TO: Bob Exstrom, Town of Parker
FROM: Stacey Nerger, Senior Planner
DATE: February 29, 2024
SUBJECT: Parker Town Hall Amendment 3 Lot 1 – Site Plan
Review Comments 02

Parker Town Hall Expansion

PARKER TOWN HALL EXEMPTION PLAN AMD3 L1 SITE PLAN SUBMITTAL

SITE PLAN

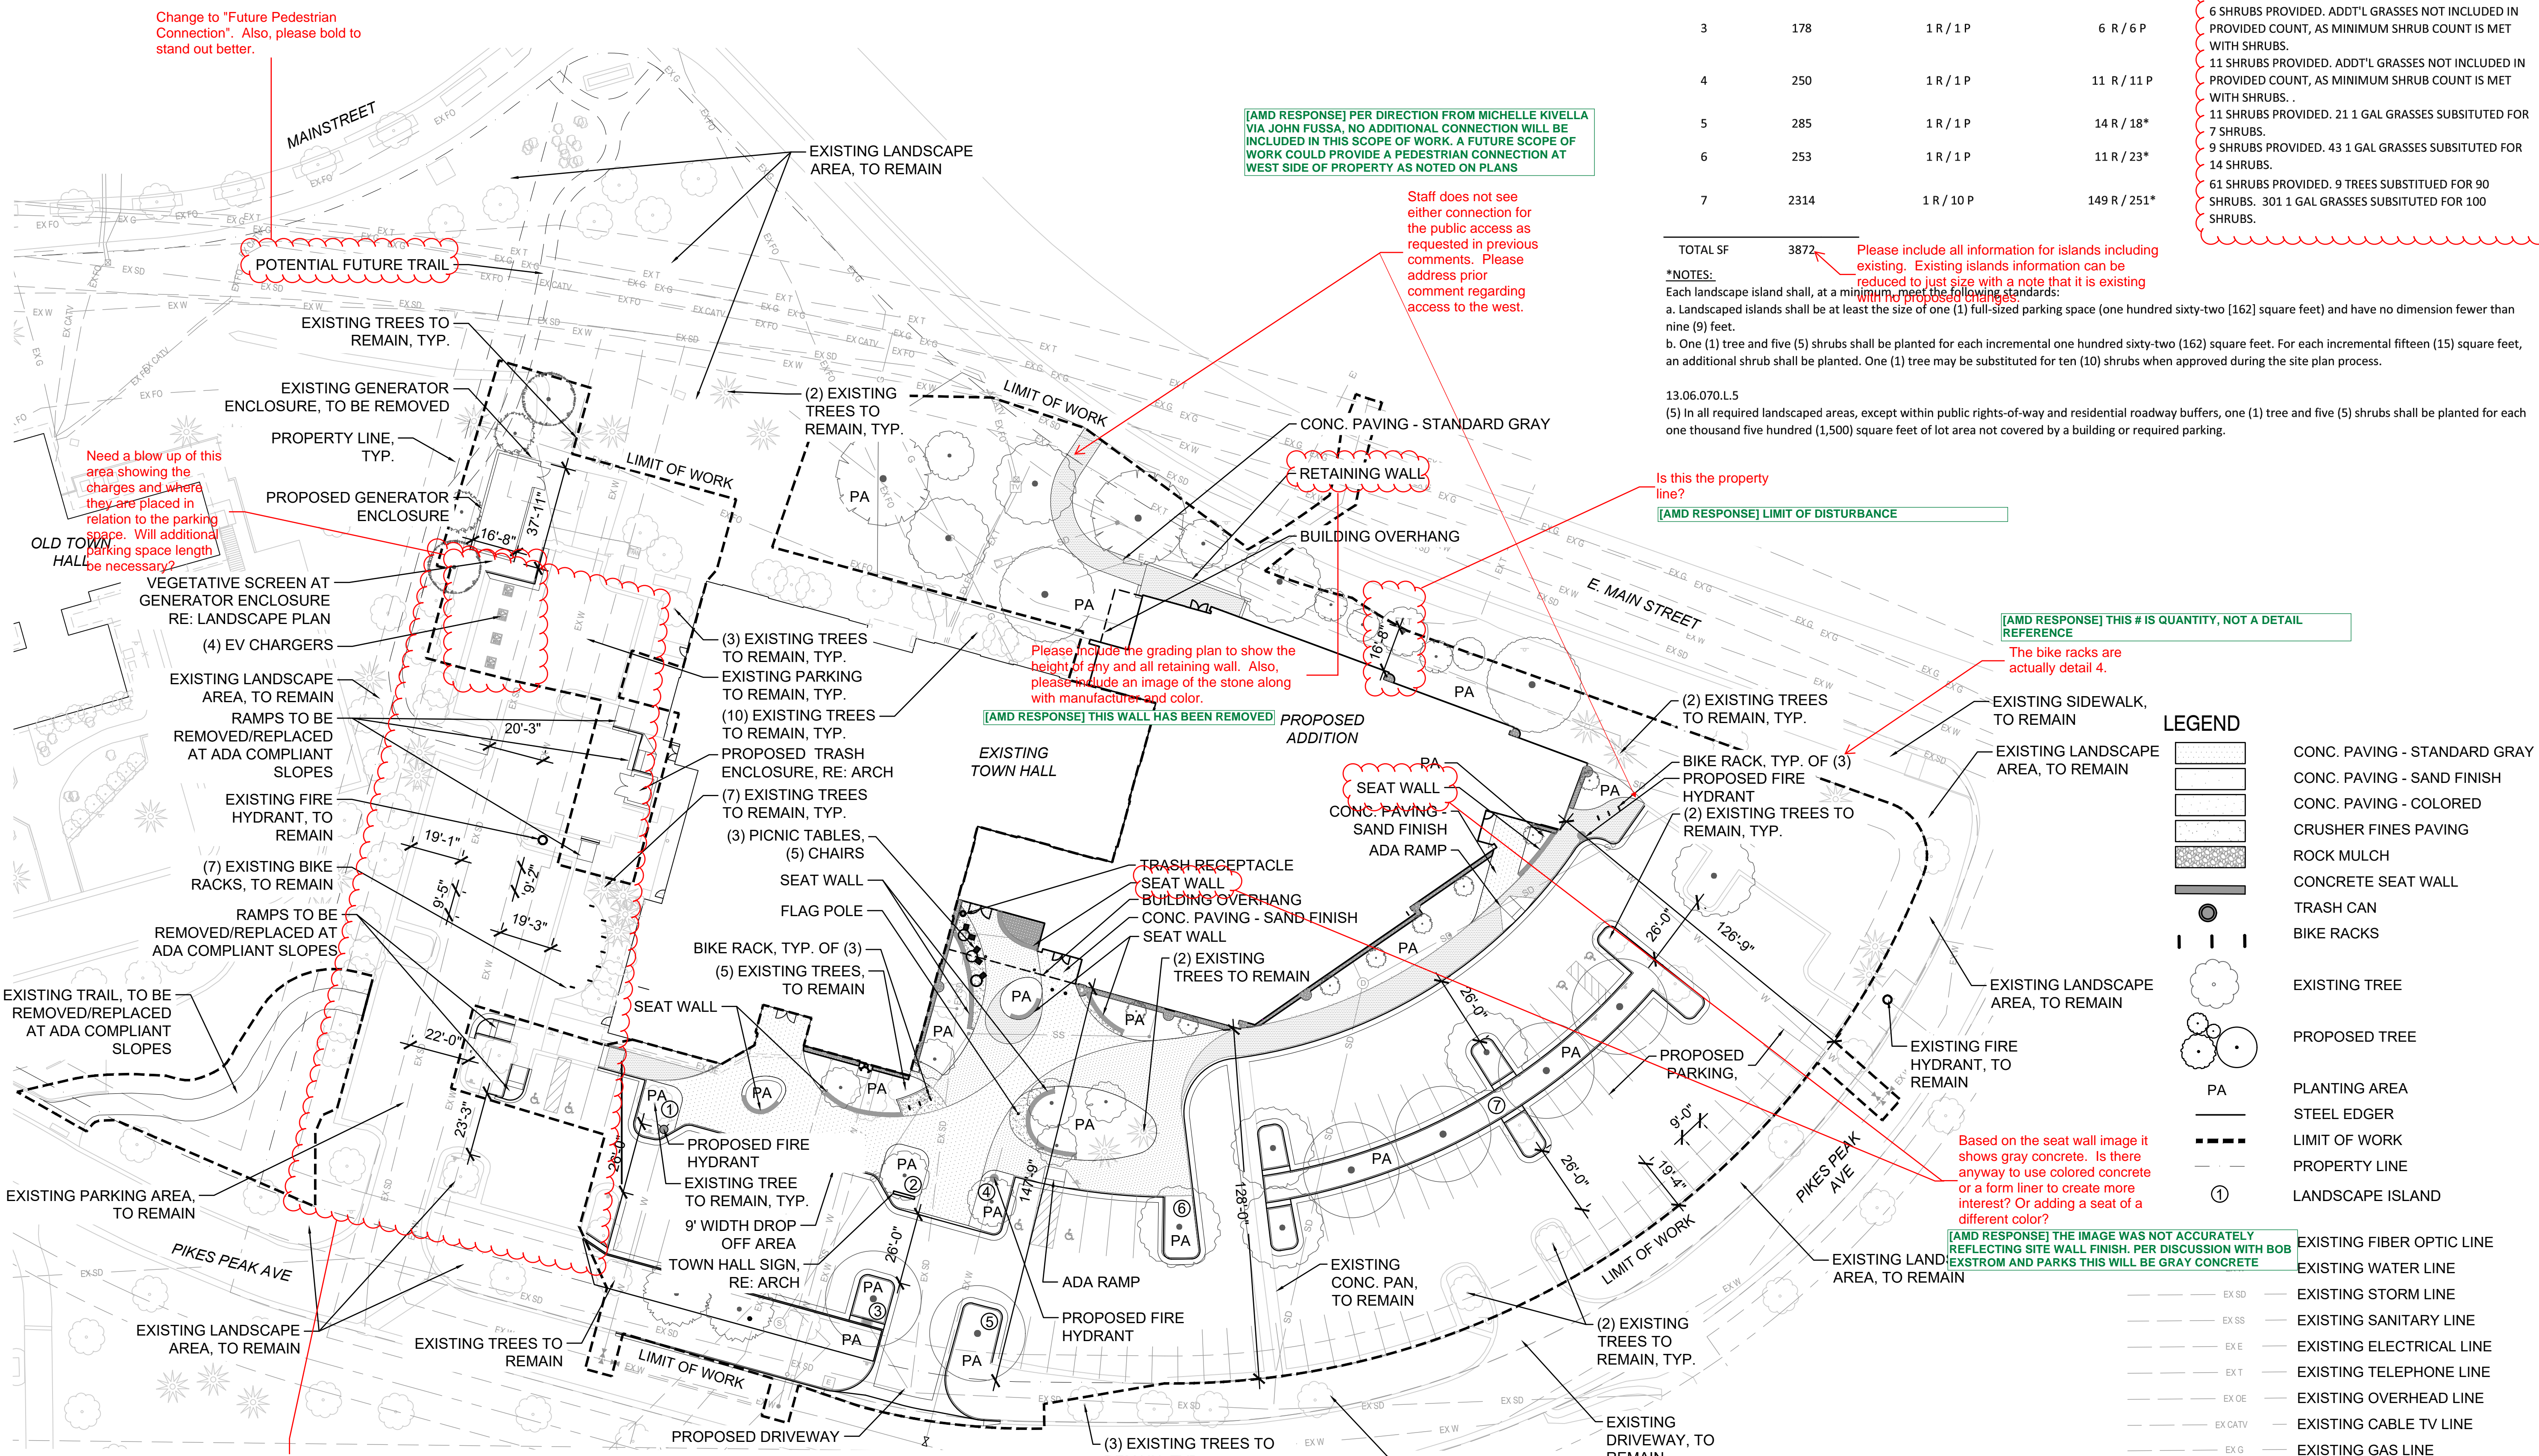
Staff does not see either connection for the public access as requested in previous comments. Please address prior comment regarding access to the west.

Is this the property line?

The bike racks are actually detail 4.

To demonstrate that the parking listed in the table is provided, please show all spaces on the Site Plan.

Green highlighted area is the property perimeter landscaping area. Based on your table you are adding landscaping. This is not shown on the plan. Most areas look to be existing and will not be changing, but please confirm. Where new landscaping is proposed please ensure it matches the requirements of the code and what is listed in the table.

[AMD RESPONSE] PER DIRECTION FROM MICHELLE KIVELLA VIA JOHN FUSSELL, NO ADDITIONAL CONNECTION WILL BE INCLUDED IN THIS SCOPE OF WORK. A FUTURE SCOPE OF WORK COULD PROVIDE A PEDESTRIAN CONNECTION AT WEST SIDE OF PROPERTY AS NOTED ON PLANS

[AMD RESPONSE] LIMIT OF DISTURBANCE

[AMD RESPONSE] THIS IS QUANTITY, NOT A DETAIL REFERENCE

[AMD RESPONSE] THE IMAGE WAS NOT ACCURATELY REFLECTING SITE WALL FINISH. PER DISCUSSION WITH BOB EXSTROM AND PARKS THIS WILL BE GRAY CONCRETE

LANDSCAPE PLAN

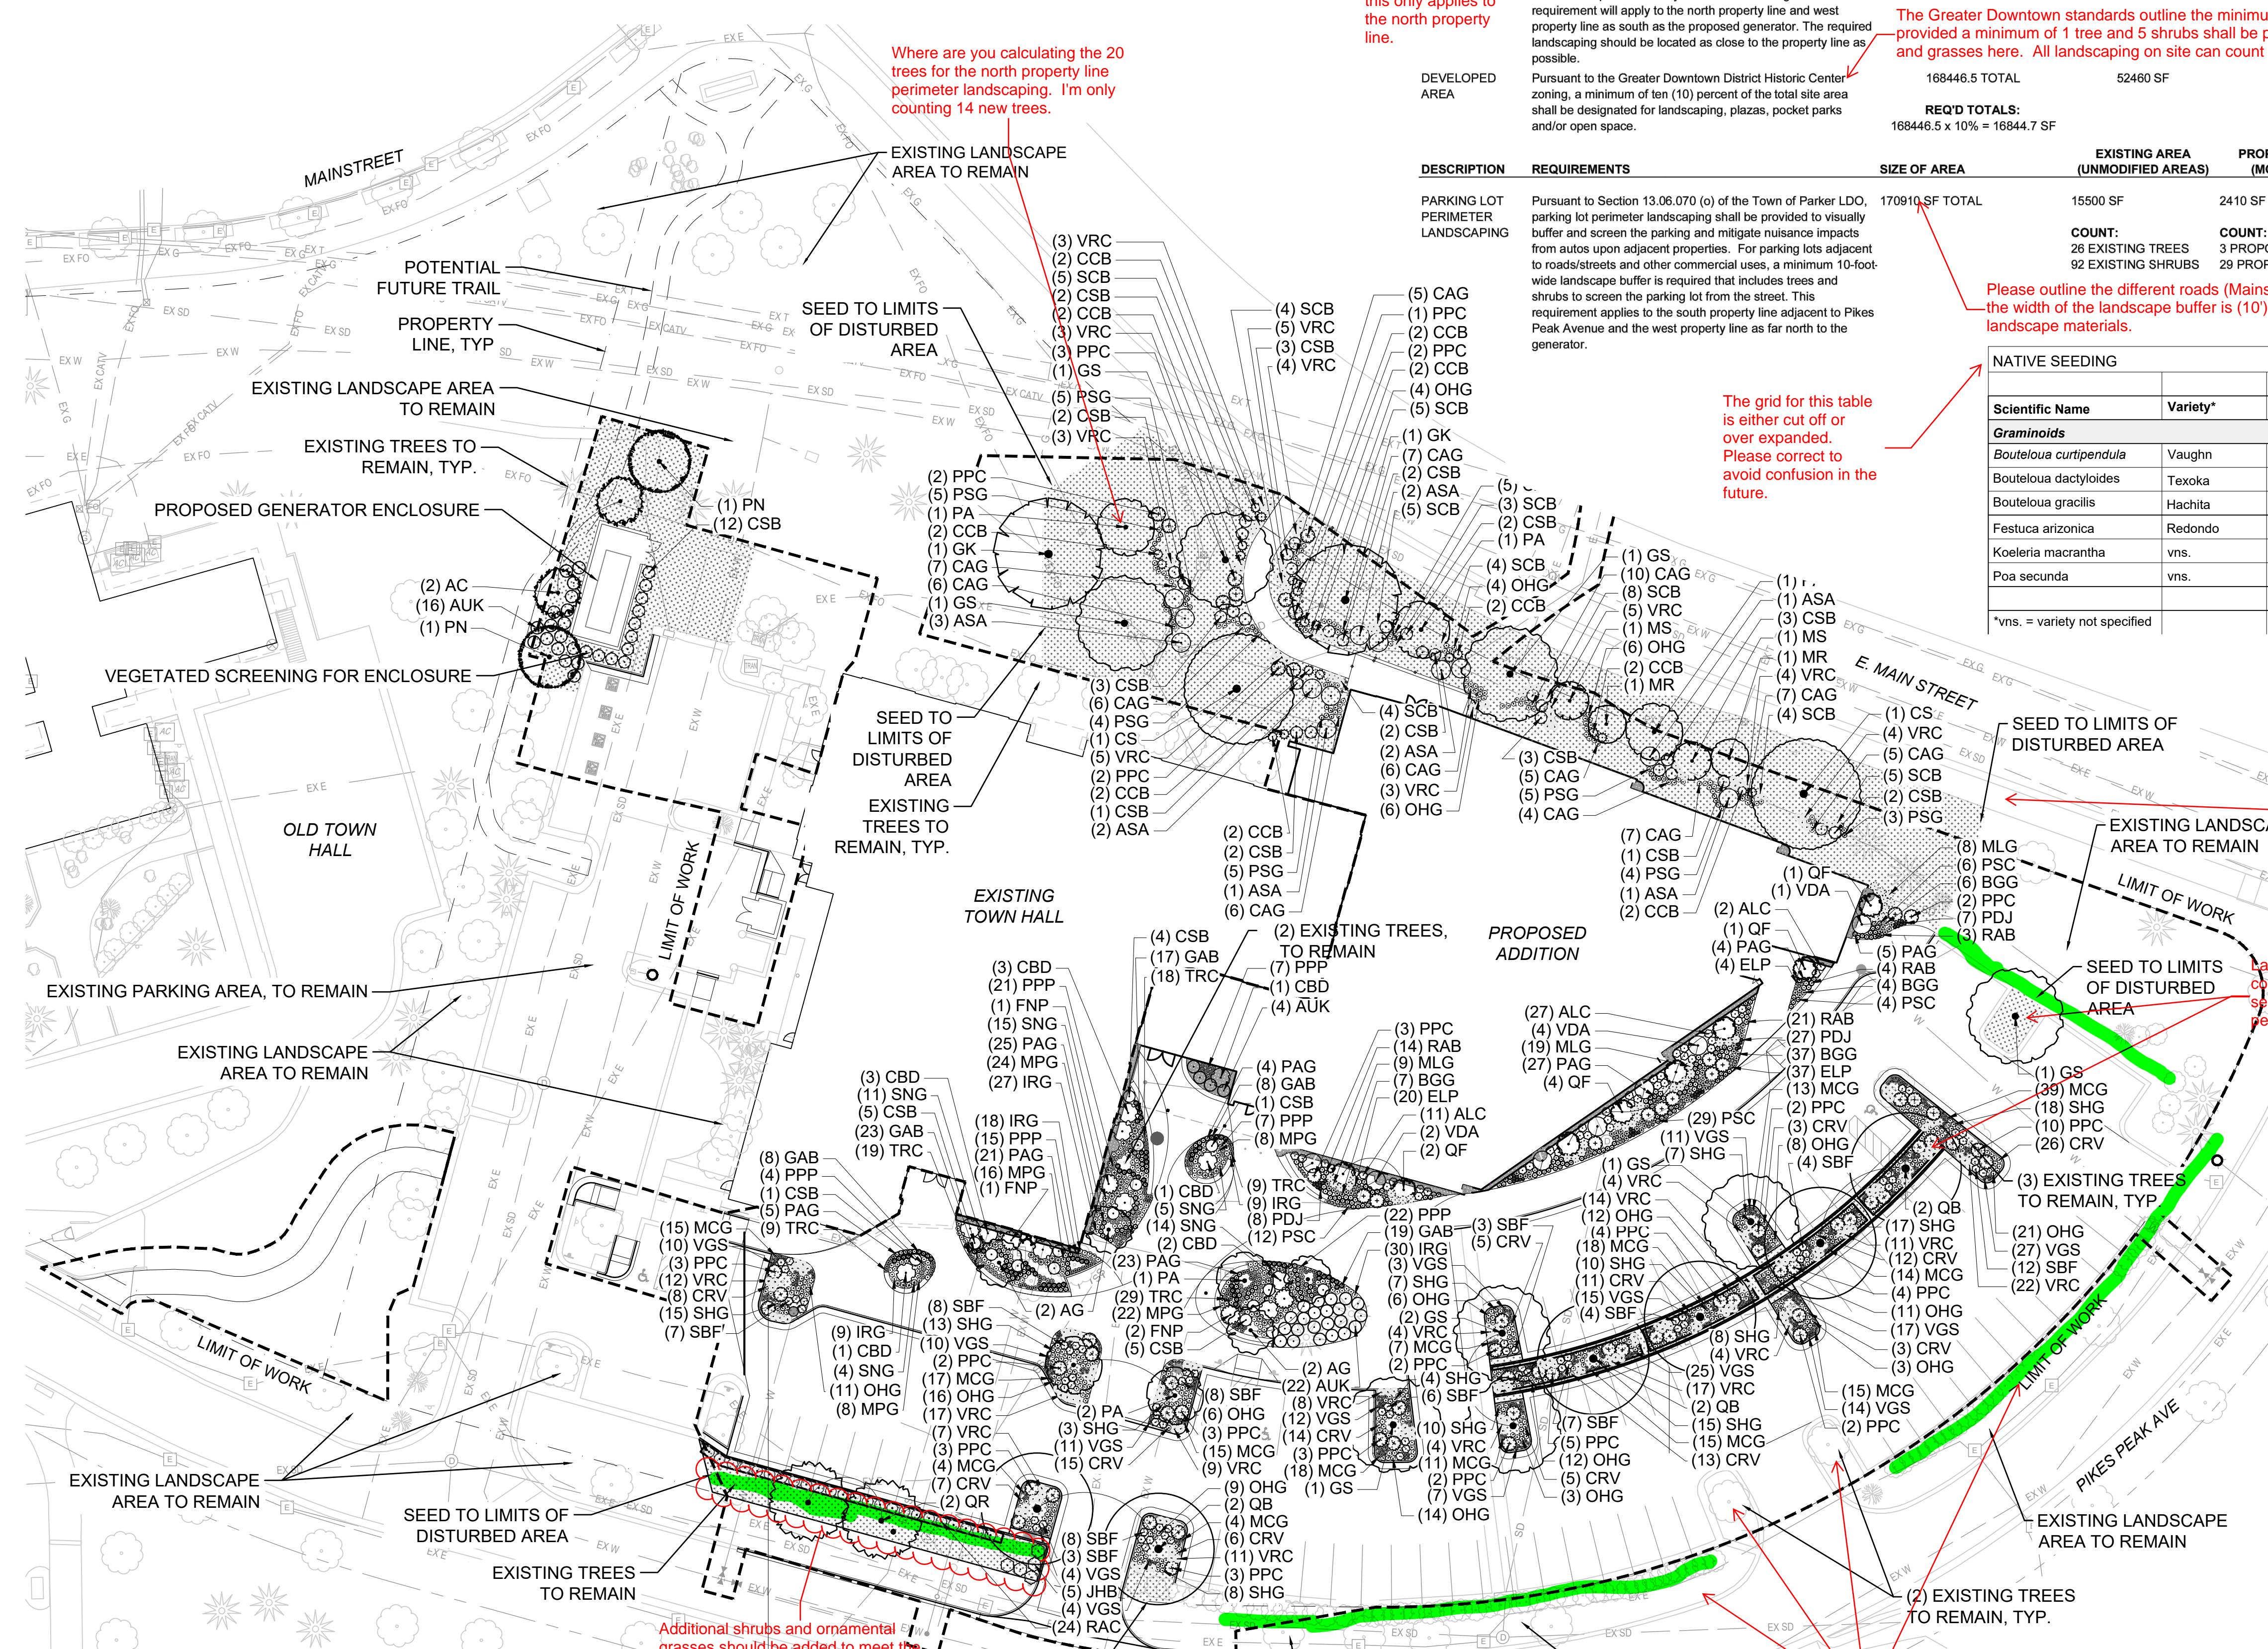
Although the area up to the existing sidewalk is not proposed to be disturbed, please include the existing landscaping on this plan. Existing landscaping should be grayed back.

Landscape islands cannot contain turf (sod) or native seed. Rocks or mulch are permitted.

NOTES:
1. SEE LANDSCAPE DETAILS SHEET 5 FOR PLANT SCHEDULE.
2. NO CHANGES TO THE LANDSCAPE PLAN ARE ALLOWED WITHOUT APPROVAL FROM THE TOWN OF PARKER.
3. 45 TREES TO BE REMOVED FOR THE NEW BUILDING EXPANSION.
Please add note regarding number of new trees.

PLANT SCHEDULE

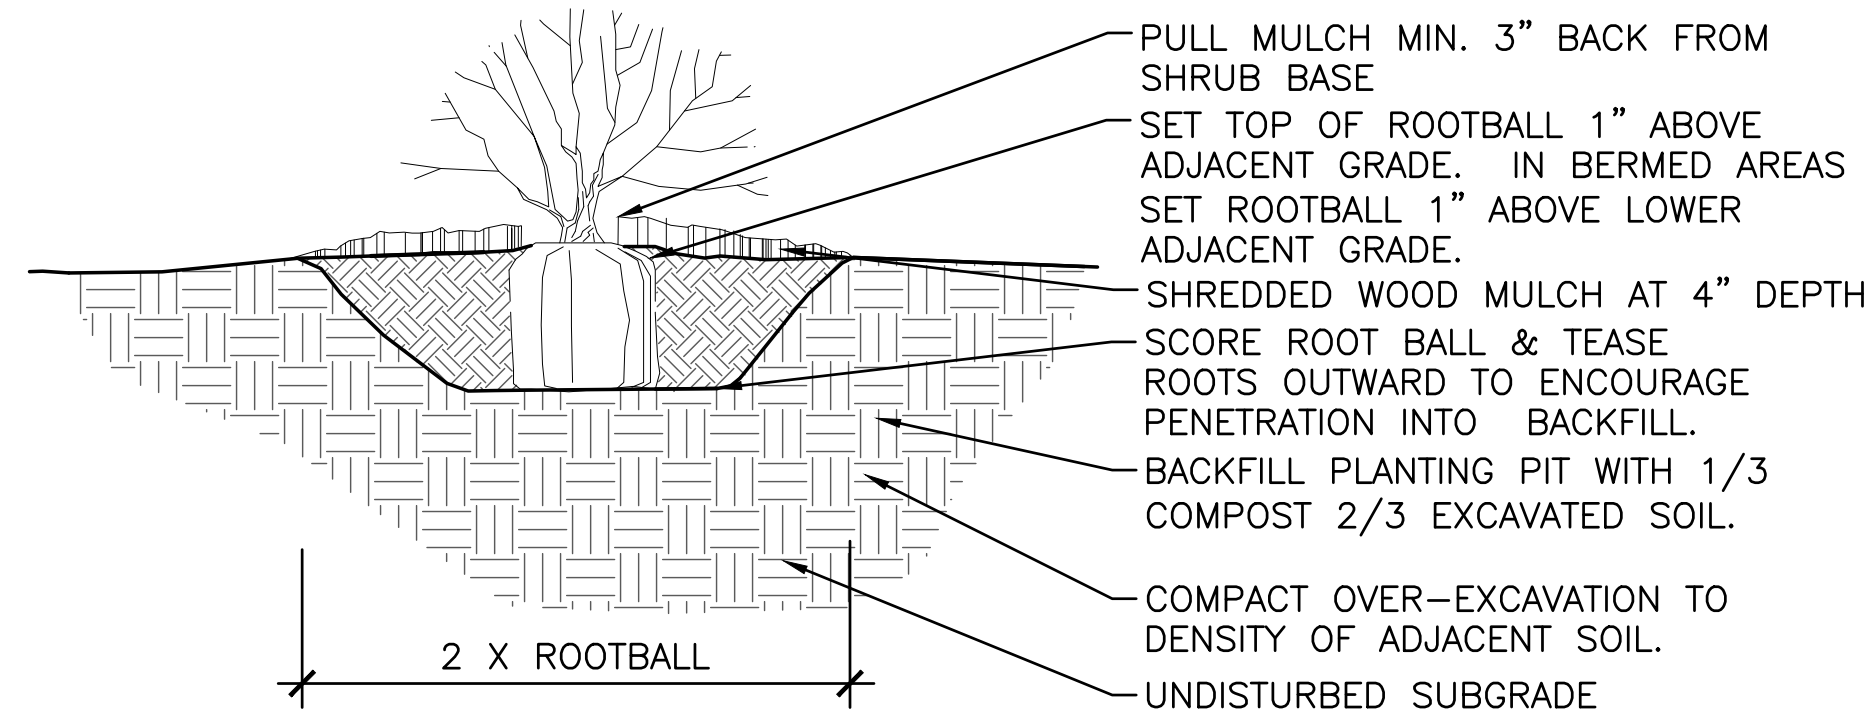
Please break this down between deciduous and evergreen trees and shrubs.

Please verify that these quantities match the landscape table and plans.

PHOTOMETRIC SITE PLAN

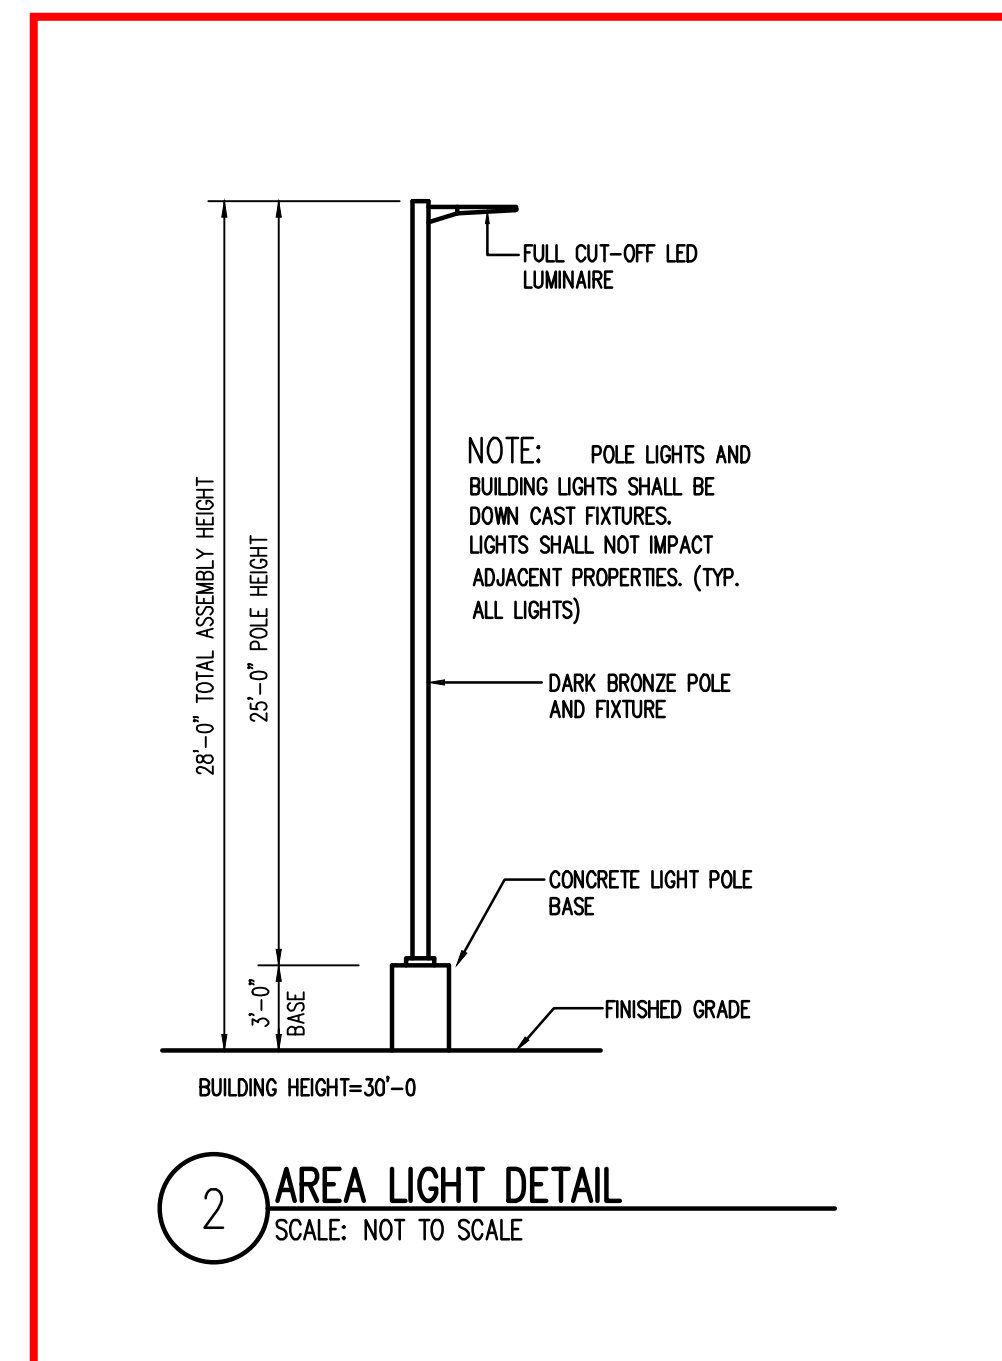
Please include an image of how the parking lot lights will be constructed.

This is not correct.

AE Design: Floodlights added here per Arch comments.

AE Design: 2 bollards added here per Arch comments

AE Design: Pole Base Elevation has been added.
